Sample Approval Form

Customer: Centra
Attention: Jagdeep Singh
CSR: Nicole Teplan
Die #: 15951
Description: (240 SERIES)
INTERIOR GLAZED
MAIN SASH
Rigid Colour: WH-115
Flex Colour: BLACK
Capstock Colour: N/A

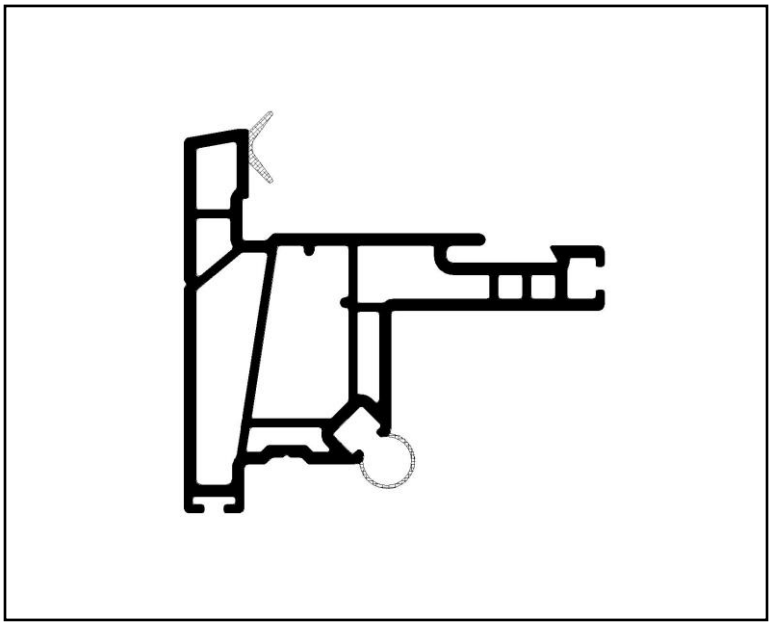
Comments: The die drawing is approved with critical dimensions identified on Vision drawing. Vision to update the weight control limits. The physical sample is approved with the dimensions received on the upper limits of wall thicknesses. It is further understood that as the die wears out the wall thickness will drift to thicker side. And the negative impact of thinner wall and overstretching during extrusion to the thermal deformation, structural attachment and profile stability are acknowledged by Vision. Normal distribution around the target thk is acceptable, but consistently thinner profile will not be acceptable.
